**UNION ELECTRIC COMPANY**

ULNRC-1210

DOCKET NUMBER 50-483  
CALLAWAY PLANT, UNIT 1

CALLAWAY LICENSE CONDITIONS C(12)

BB-PV-8702A, EJ-HV-8701B ALARM CIRCUIT  
(TYPICAL)

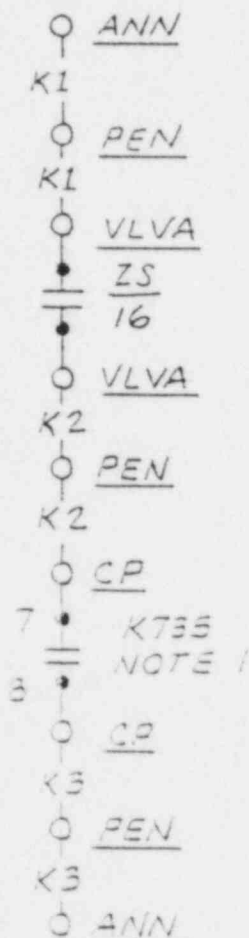
During the course of completing the detailed design of this modification it was determined the modification as proposed in Reference 1 would perform its intended function, but would produce alarms that could not be cleared, even with correct valve alignment. This is because the alarms would be generated above the interlock activation setpoint of 682 psig, when power was removed from the valves, as procedurally required. In order to remedy this situation, Union Electric proposes modified alarm circuits which will alarm only if either valves BB-PV-8702A or EJ-HV-8701B is open at pressures above the interlock setpoint. A single annunciator window will represent these two alarm circuits, but they will be alarmed individually on the Balance of Plant Computer.

The newly proposed alarm circuits do not affect the analysis provided in Reference 1 with regard to compliance to Standard Review Plans 5.2.2 and 5.4.7 and the corresponding Branch Technical Positions RSB 5-2 and 5-1. In the previously approved design, valve position was provided indirectly by an auxiliary relay at the motor control center and was therefore not available when power was removed from the valves. The newly proposed circuits are an improvement due to this design not relying on

power to the valve actuator to provide the alarm. This is because the valve position inputs for the alarms now come directly from valve stem mounted limit switches and power is provided by the annunciator system. An alarm response procedure will direct the operator to verify valve closure upon receipt of this alarm. The attached sketch depicts the alarm circuits which are currently proposed.
